REGULAR MEETING OF THE PLANNING COMMISSION

Monday, July 06, 2026

A. West Villages Residences – 315 N Lapeer Street

**Subject: VLO-25-03 West Village (315 N Lapeer Road), Final Site Plan Review
Planning Commission Reconsideration**

ARCHITECTURAL SITE PLAN
 SCALE: 1"=20'-0"

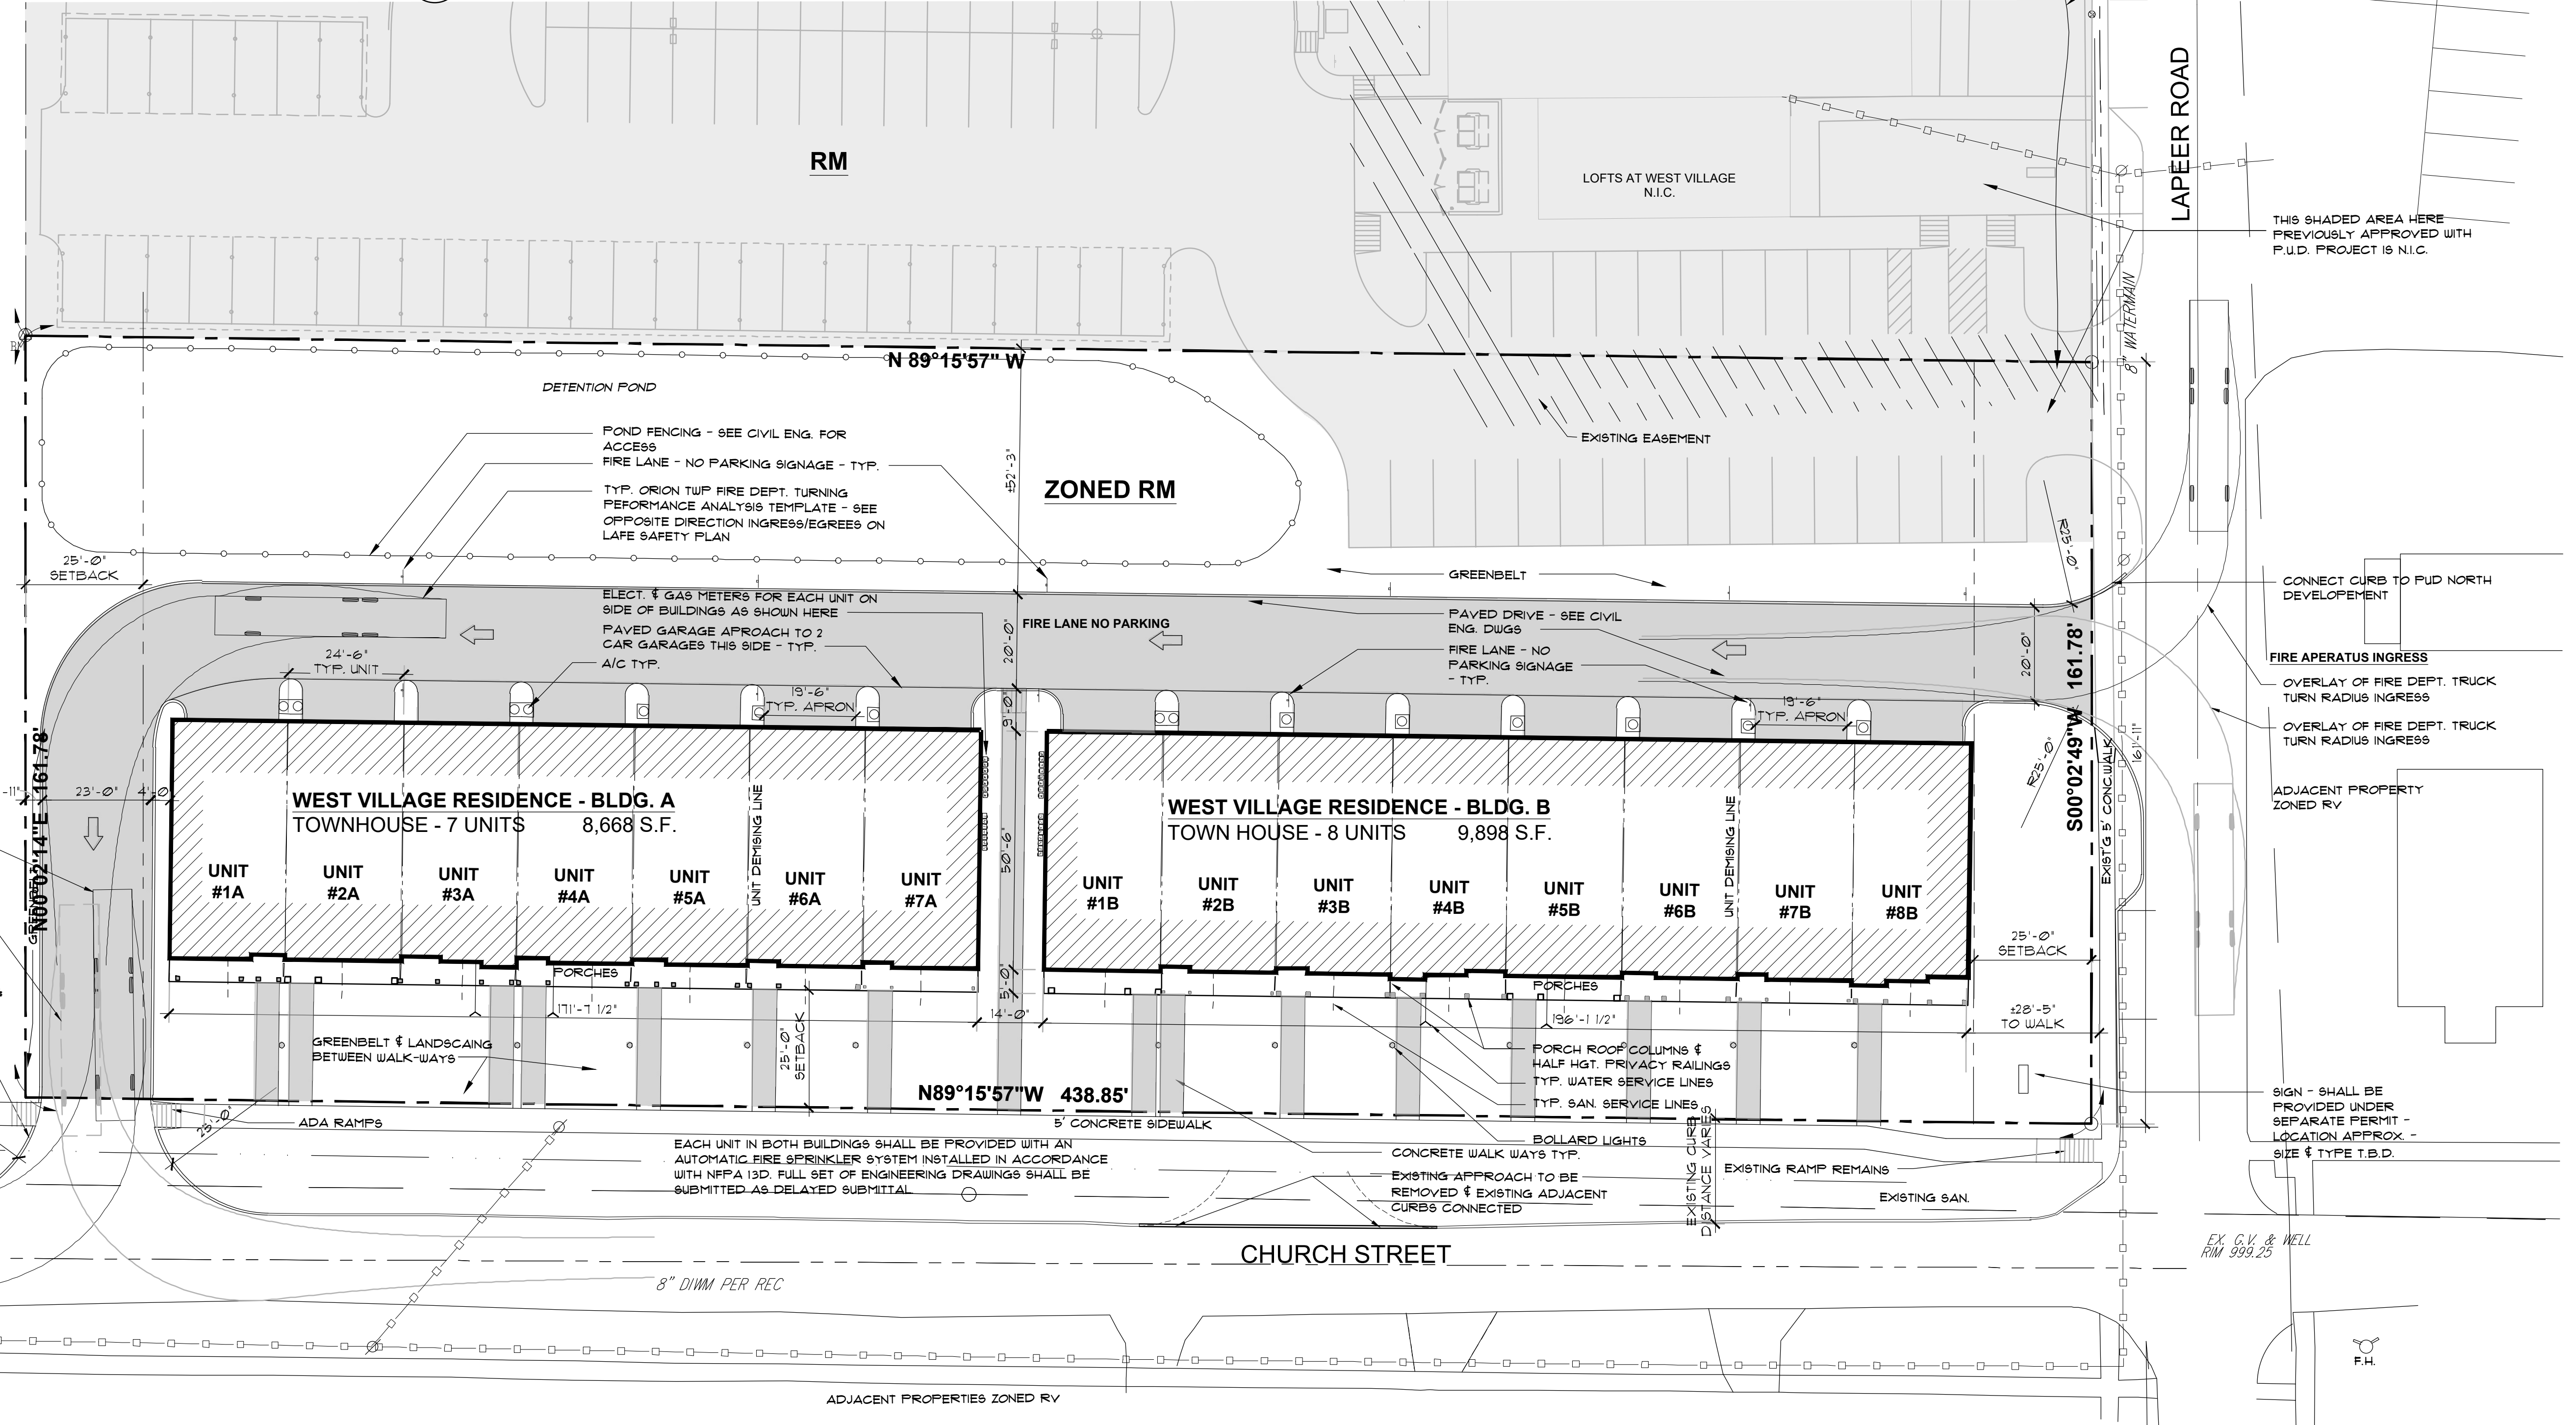
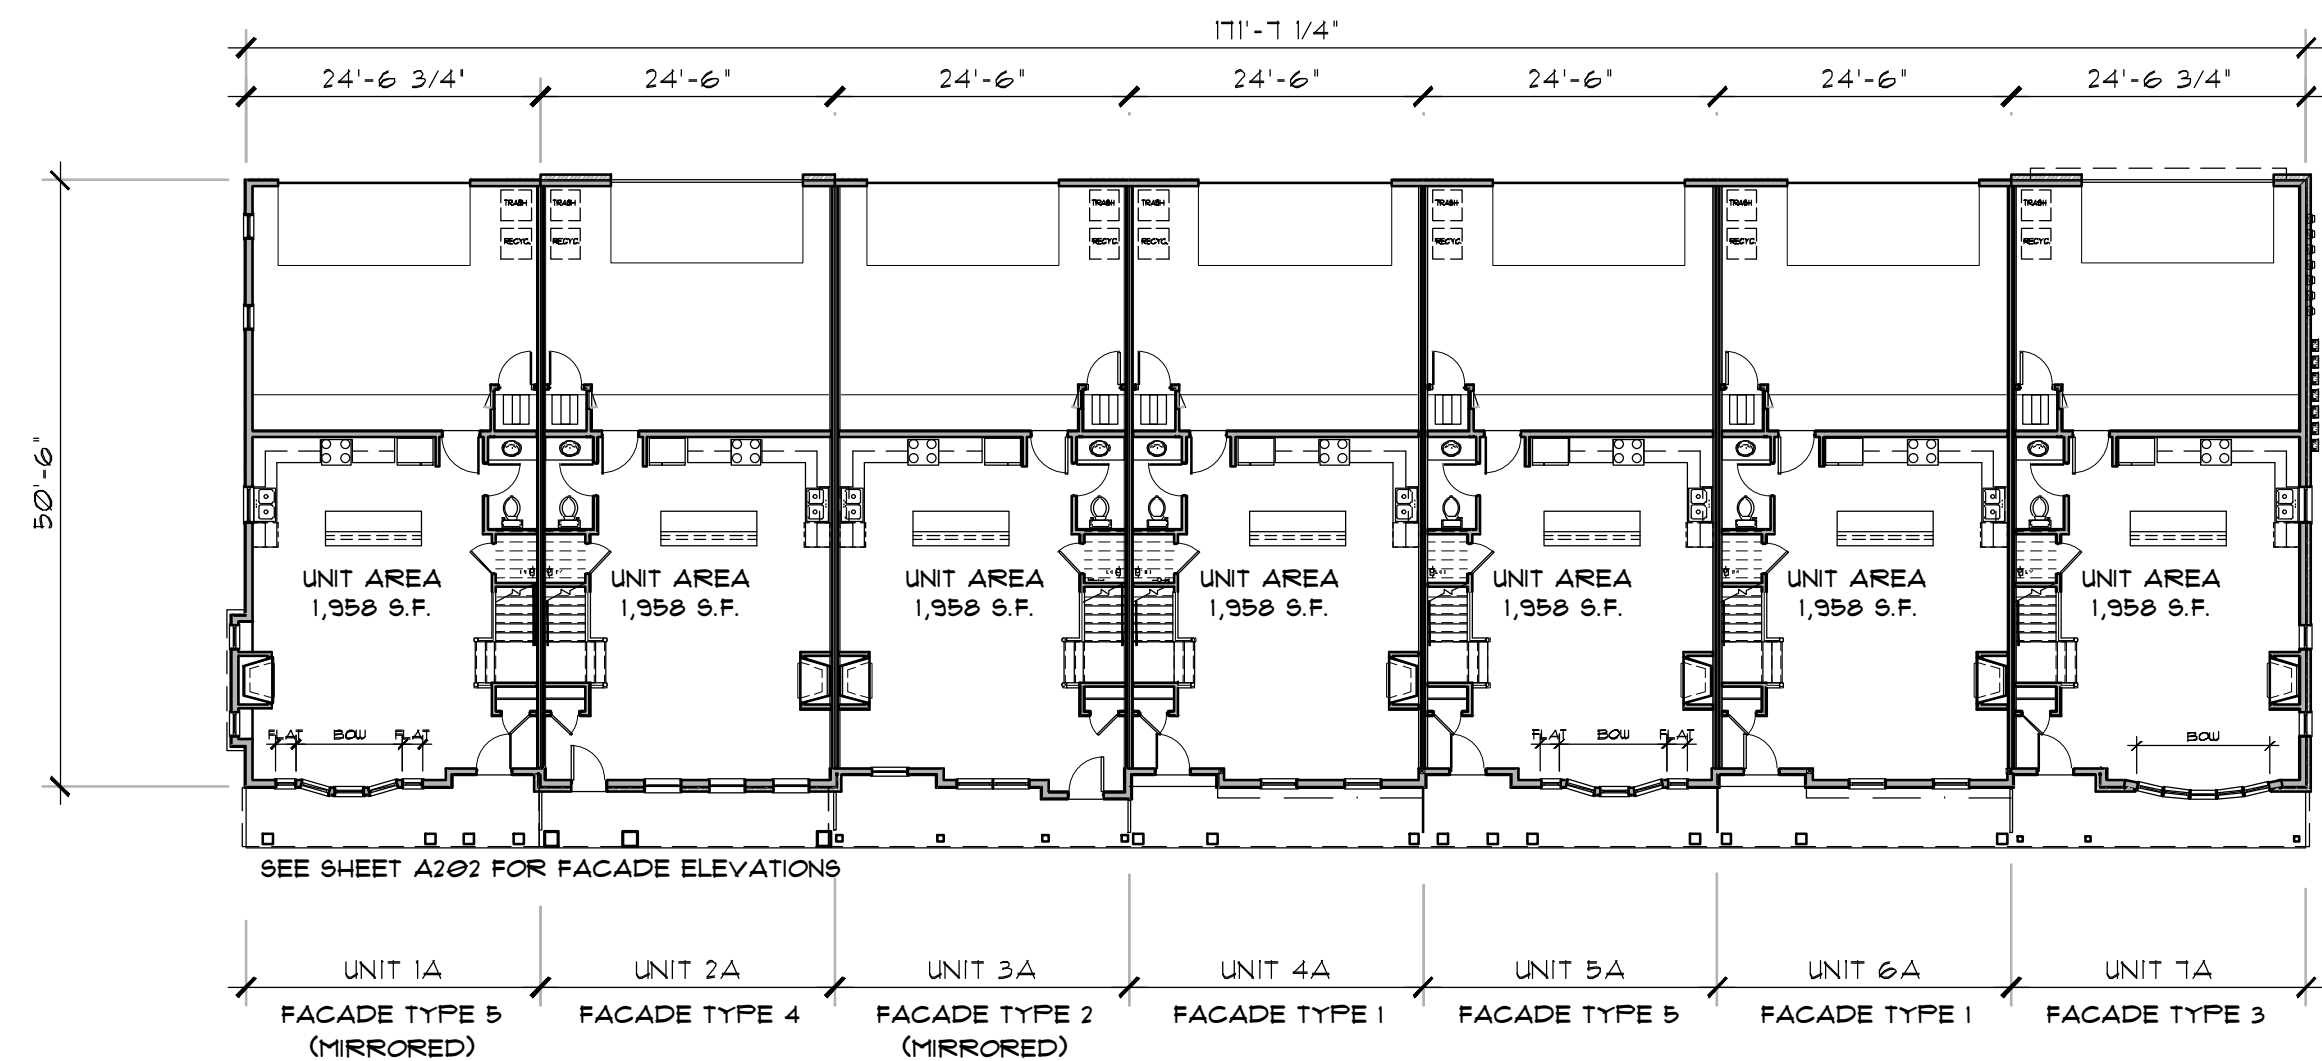
- The revised detention basin as shown by the architect's plan SP 101, which we know from our reviews of the design engineer's detention design plans is not large enough to provide the required detention volume in an open pond...

- Parallel parking (14 spaces) along Church Street, as required by the approved PUD agreement and as shown in the design plans for the West Village PUD site have been revised to indicate angled parking (18 spaces)...

- The revised layout relocates the proposed access drive to Lapeer Street further north than shown on the conditional approval. This revised location requires the relocation of a utility pole previously encompassed by a curbed island in the West Village PUD engineering plans. The developer may wish to consider the feasibility and cost impact of this relocation.

- As noted in the previous section, the submitted plans do not meet the requirement for a site plan submittal. Provide all required information, overlaid on the topographic survey with the survey shown to the extents required, including adjacent driveway locations both sides of the streets, to 100' past the site boundary. Refer to Zoning Ordinance Section 19.02D

- The "Parking Information" chart provided mixes the parking spaces required by the PUD approval of the adjacent site with spaces credited toward the proposed Residences development. Provide accurate parking information that meets both the PUD requirements and the parking required for the Residences.

- Provide consistent detention design information between this site and the adjacent PUD site. Design must meet all requirements of the Village MS4 permit / Oakland County WRC stormwater engineering design standards. Detention must be provided for the Residences, and engineering plan approval is required before any building permit could be issued.

- Provide preliminary utility service information for the Residences. Various incarnations have shown individual sewer and/or water services for each unit, public utility extensions to the site, or one service per building to be split internally. Decide how service will be provided, and show the relevant required information (eg. location of meter rooms / riser rooms with required access; location of proposed public utility extensions / individual unit meters).

- Provide evidence that the adjacent property owner to the west accepts the proposed driveway opening encroaching across their frontage.

- The actual location of the paving in Church Street is not shown across the entire site frontage plus 100’ beyond the boundary as required. It is not possible to verify the fire apparatus template fits the proposed site and existing street at the western access drive.

- Parking information revised to list this project only.

- Acknowledged. Fire department apparatus templates shown in plans for all directions.
